We, Shenzhen Intellirocks Tech. Co., Ltd., hereby apply for Class II permissive change to the approved product under FCC ID: 2AQA6-H6008, date of original grant: 08/11/2021.

There are three changes, as follows:

Antenna Dimension

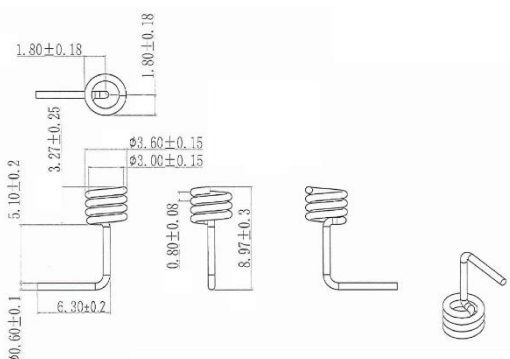
1. The antenna has been modified.

In the RF circuit section, there are no modifications except for the replacement of the antenna. In addition, there are no modifications to the motherboard circuit.

Ant.	Type	Operation Frequencies (MHz)	Gain (dBi)	Manufacturer
Original	Spring	2400~2500	1.5	Shenzhen Qianyan Technology LTD
New	Spring	2400~2500	-0.41

Original	New

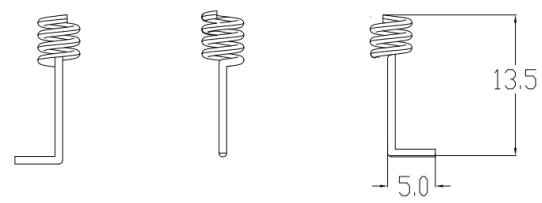
2. An aluminum cooling device was added to the original metal structure
